TO ALL BIDDERS: Renovations of the Library on the Kemper Campus
Boonslick Regional Library – Cooper County Branch

Item No. MEP1 – CHANGE – RE-ISSUE ALL PLUMBING SHEETS

7 LOWER LEVEL DOMESTIC WATER DEMO AND RENO DETAIL
NO SCALE

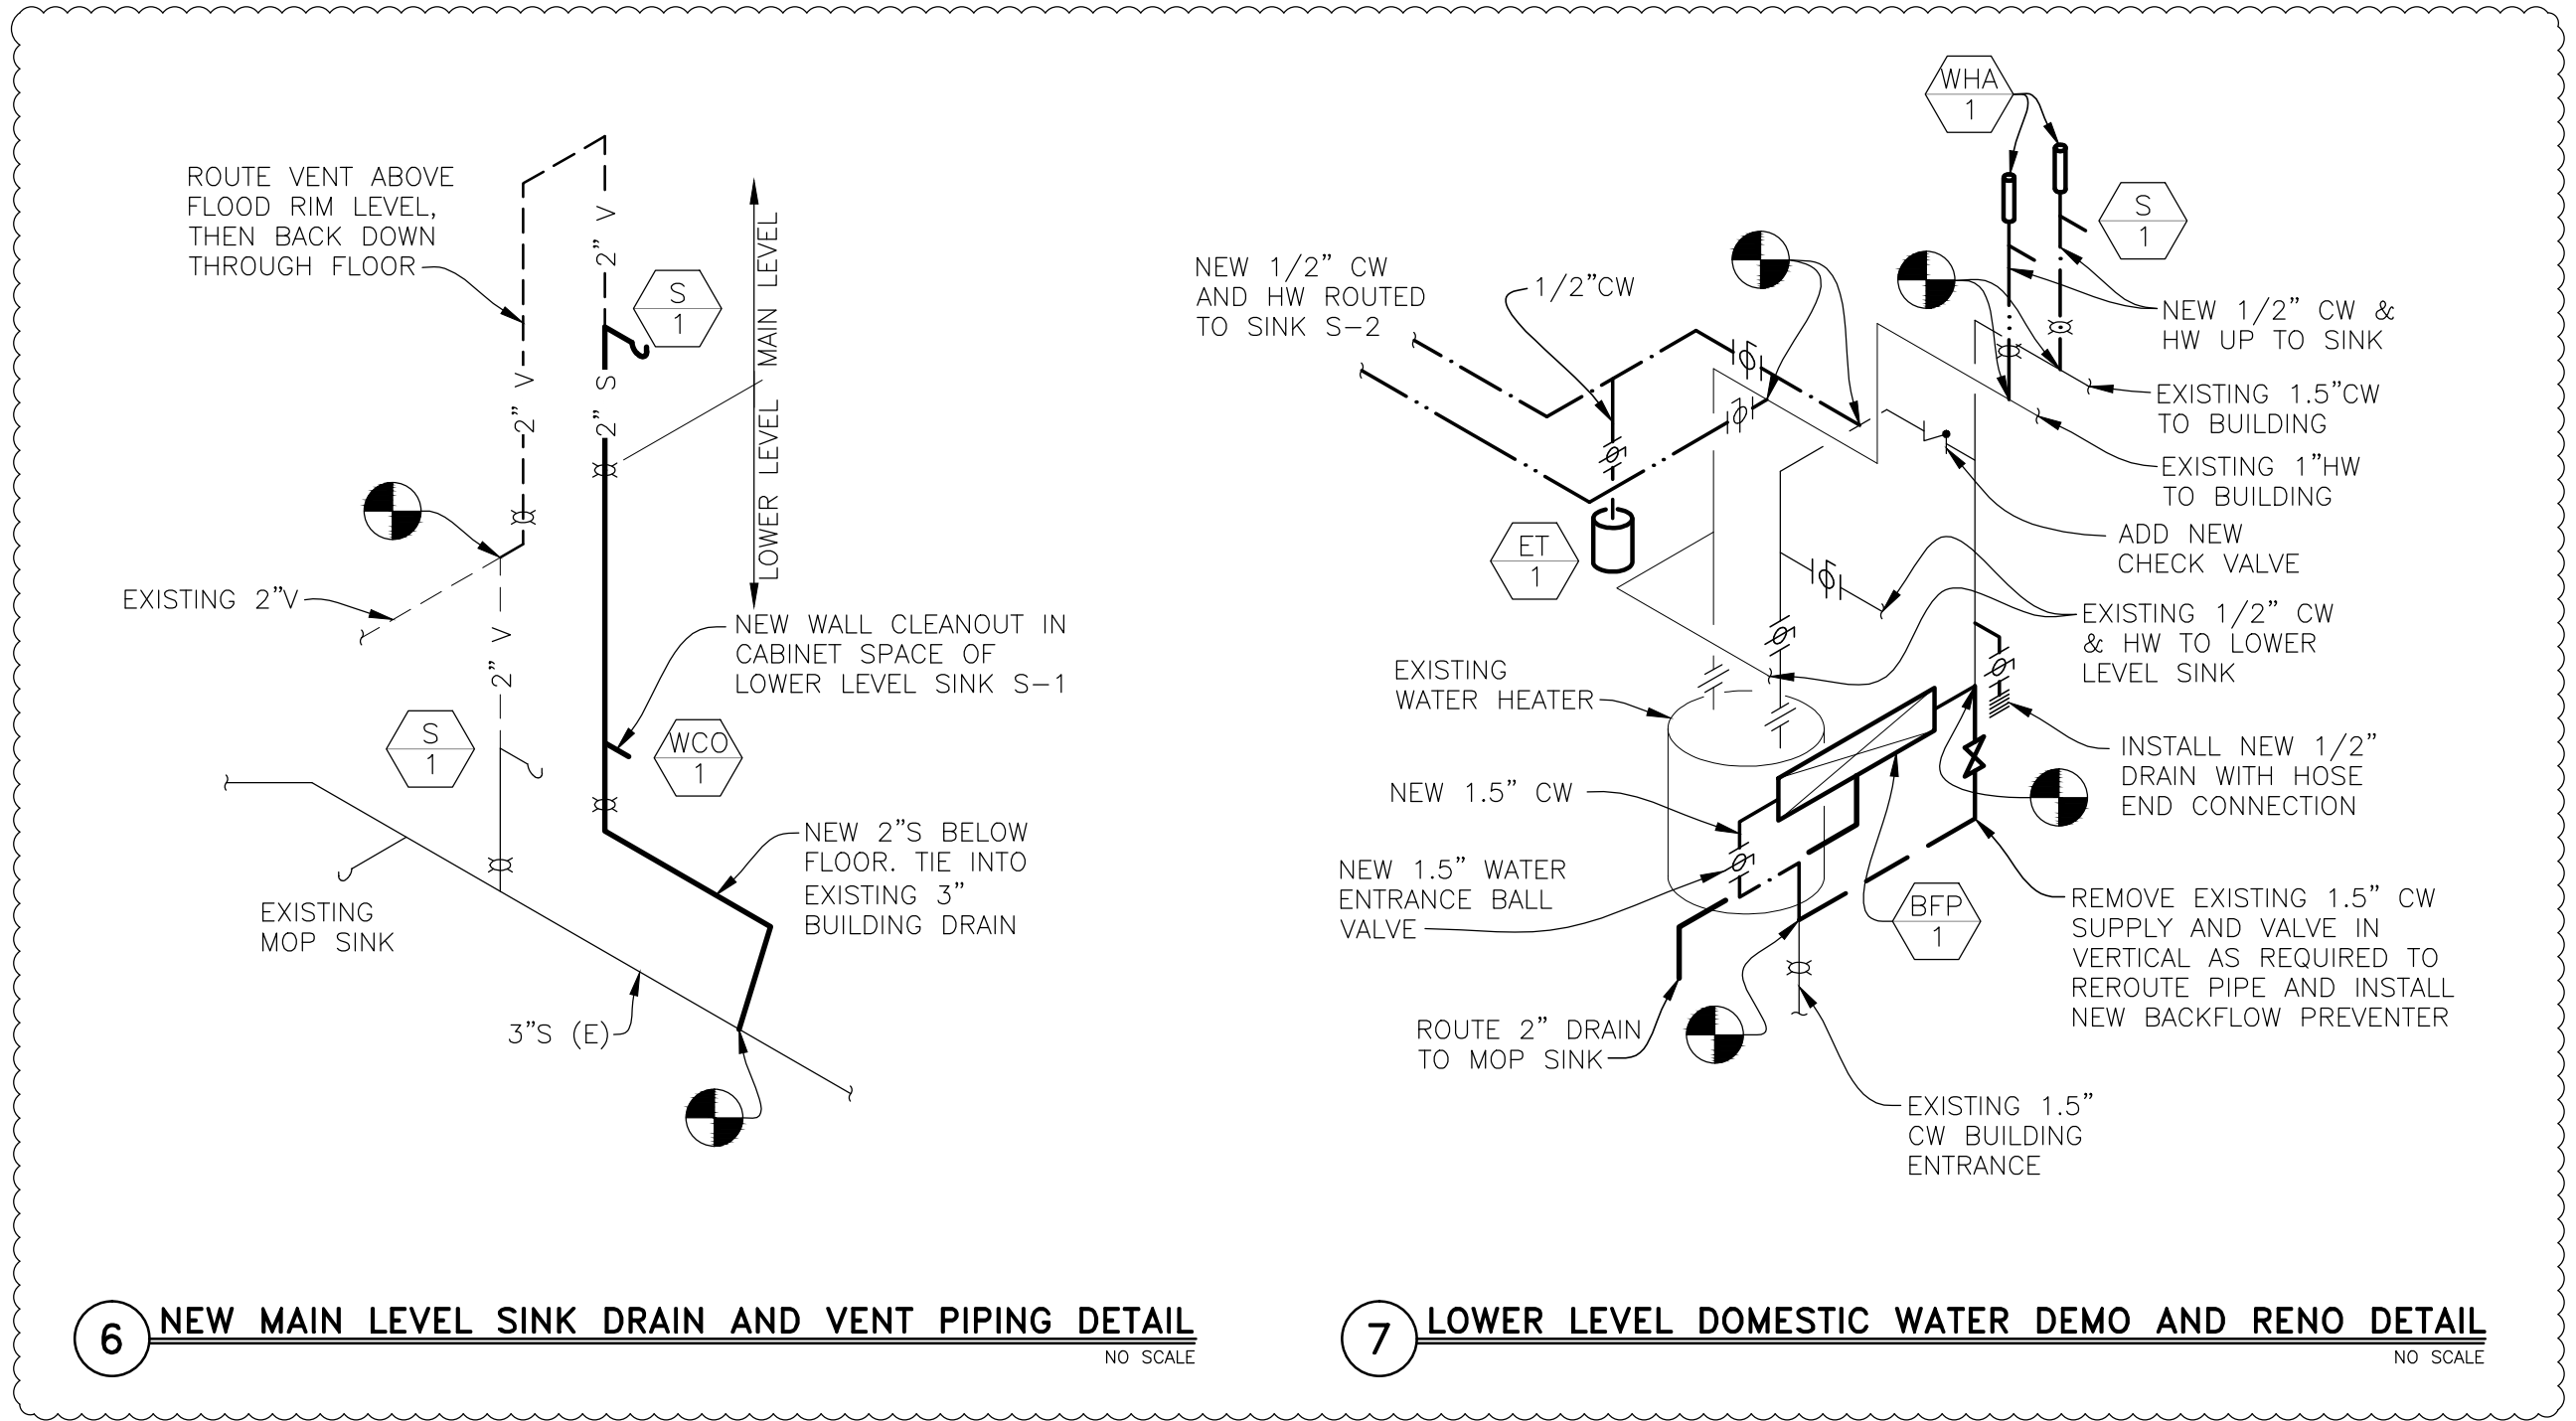
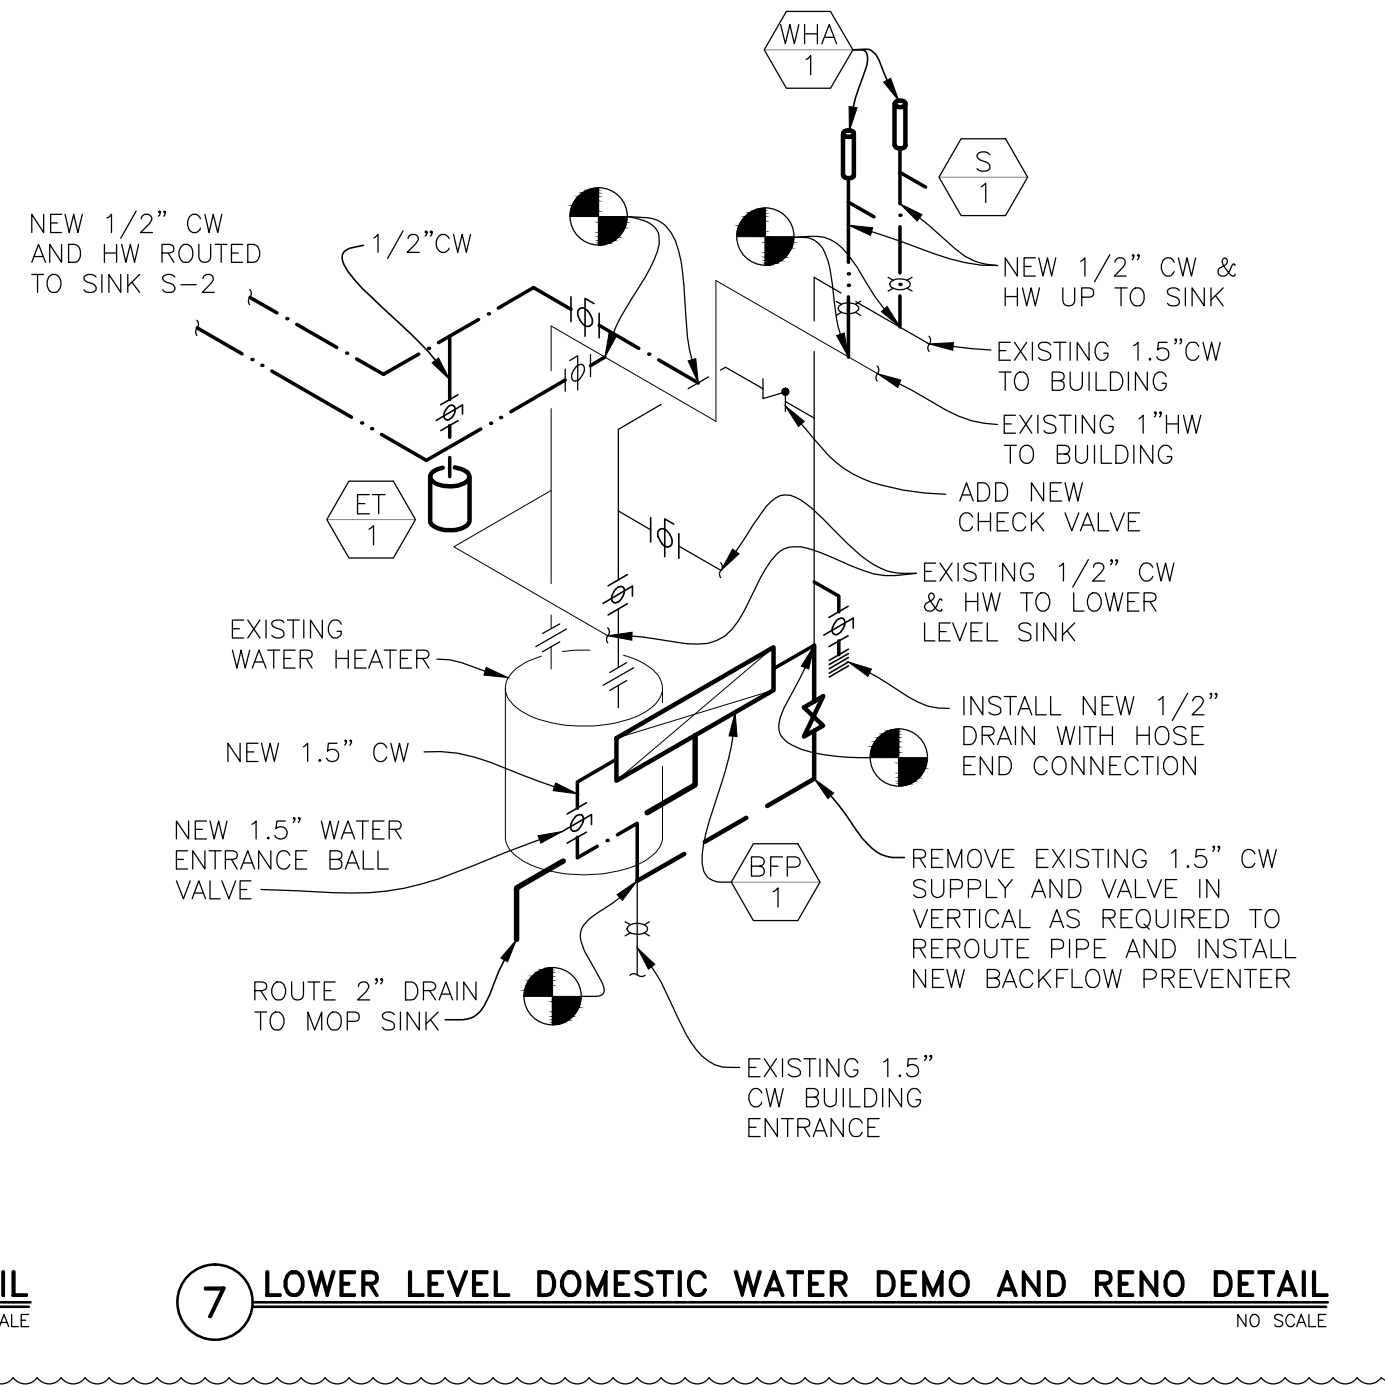
- 1) Two isometric details are added for the Main Level sink S-1 drain, and modifications to the domestic water system for two sinks, the addition of a new backflow preventer, and the addition of an expansion tank.
- 2) An expansion tank schedule was added.
